# Vista Del Norte Estates Unit Five

City Plan Commission — August 14, 2025 **[REVISED]**

**CASE NUMBER/TYPE:** SUSU25-00069 – Major Combination  
**CASE MANAGER:** Alex Alejandre, (915) 212-1642, [AlejandreAX@elpasotexas.gov](mailto:AlejandreAX@elpasotexas.gov)  
**PROPERTY OWNER:** Ranchos Real IV, LTD  
**REPRESENTATIVE:** Conde, Inc.  
**LOCATION:** South of Stan Roberts Ave. and West of Dyer St. (District 4)  
**PROPERTY AREA:** 115.18 acres  
**VESTED RIGHTS STATUS:** Vested (Prior to June 1, 2008)  
**PARK FEES:** Park Fees Not Required  
**EXCEPTIONS/MODIFICATIONS:** Yes, see following section  
**ZONING DISTRICT(S):** P-R I (Planned Residential I)  
**RELATED APPLICATIONS:** SUB08-00042 (Vista del Norte Amending Land Study)

1. To waive the construction of one-foot (1') of planter strip along Norte Vista Drive.

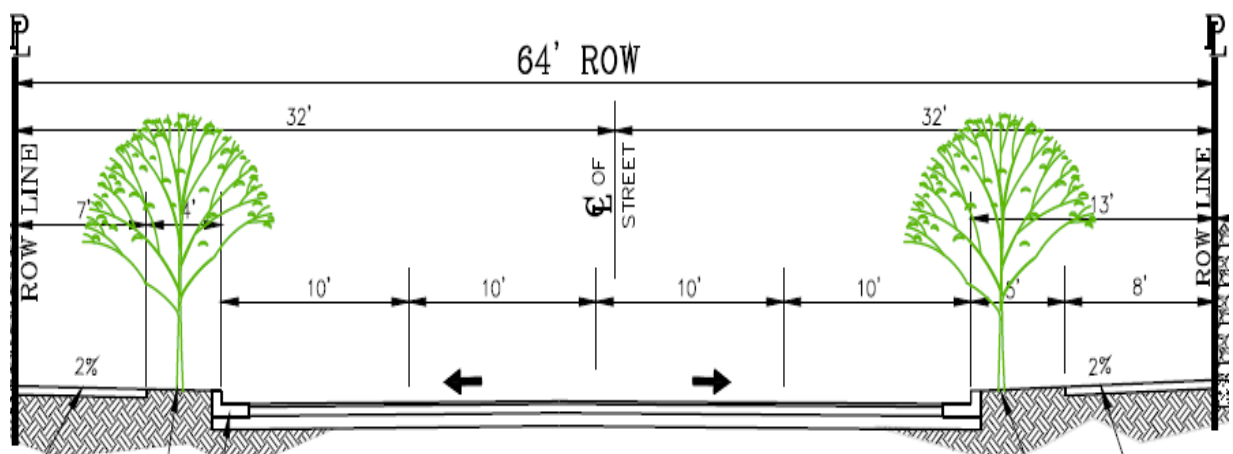
**EVALUATION OF EXCEPTION REQUEST:** The exception requests to waive right-of-way improvements meets the following criteria under El Paso City Code 19.10.050(A)(1)(a) – (Roadway Participation Policies— Improvement of Roads and Utilities Within and or Abutting the Subdivision). The section reads as follows:

**VISTA DEL NORTE  
ESTATES UNIT FIVE**  
BEING A PORTION OF TRACT 1,  
SECTION 10, BLOCK 80, TOWNSHIP 1,  
TEXAS AND PACIFIC RAILROAD CO. SURVEYS,  
CITY OF EL PASO, EL PASO COUNTY, TEXAS  
CONTAINING 115.488 ACRES.  
**PRELIMINARY PLAT**

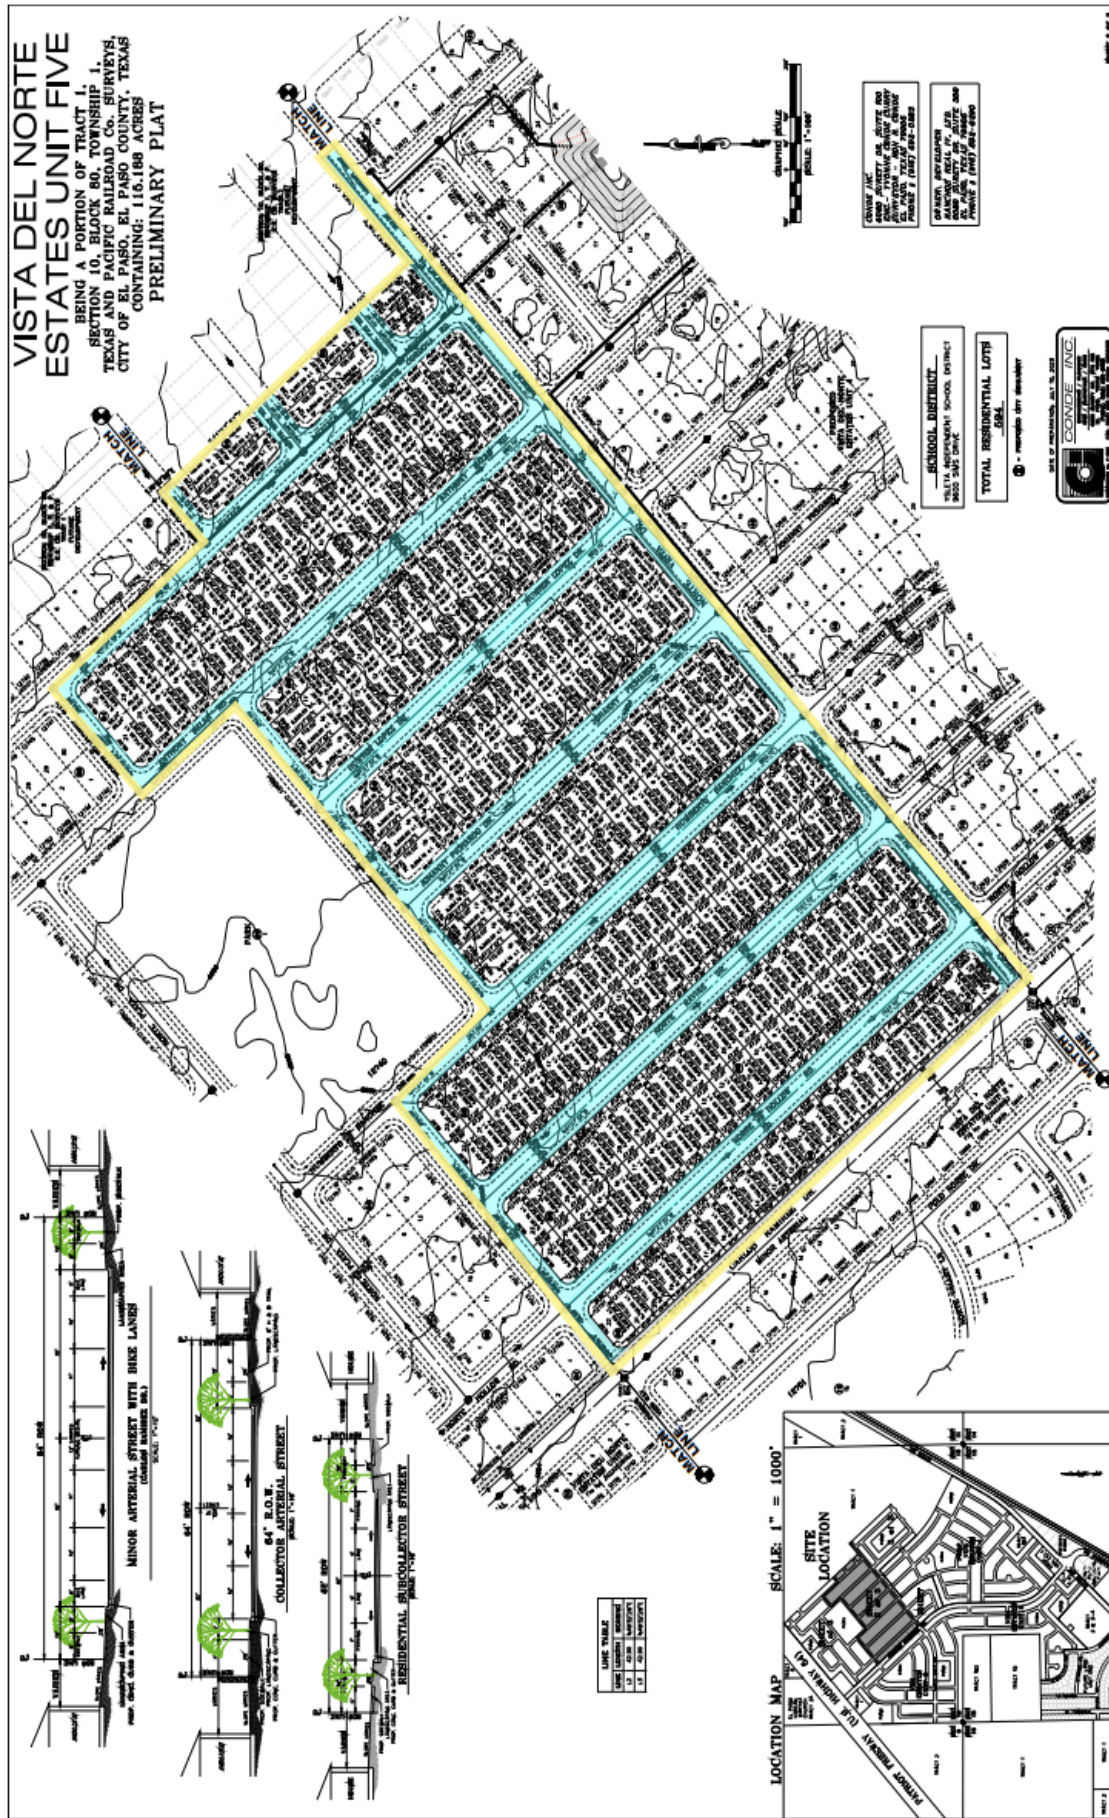
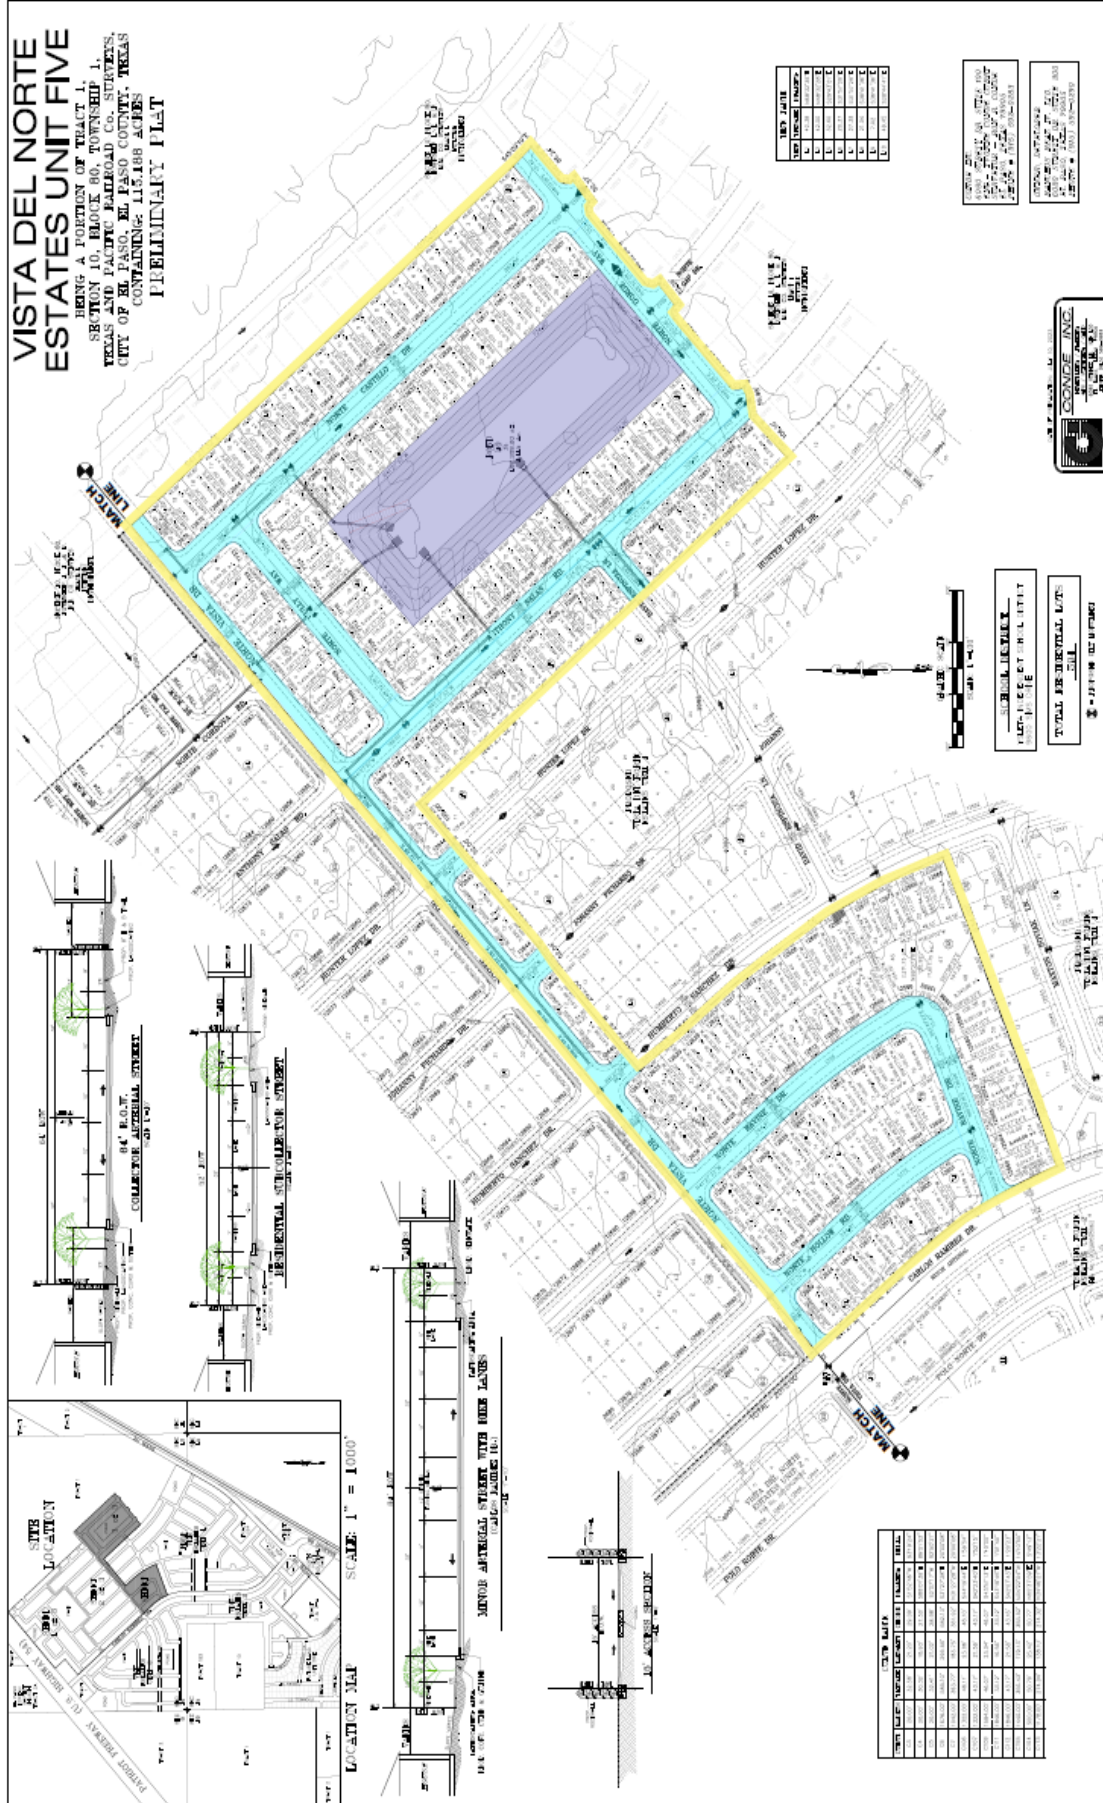
1. Coordinate with TXDOT for access and drainage requirements. Obtain TXDOT approval for the deceleration lane and driveway.
2. Print-out of the mathematical closure is ok.
3. Provide total number for park and/or ponds on final plat sheet 1.
4. At all proposed dead-end streets, provide a Dead-End temporary turnaround location and radius dimensions.
5. Verify proposed turning heel at North Ravine Drive in compliance with the DSC.
6. Provide benchmark note in the preliminary plat.

- Recheck Page 1 and Page 3. Block 71 have the same lot numbers (1&2).
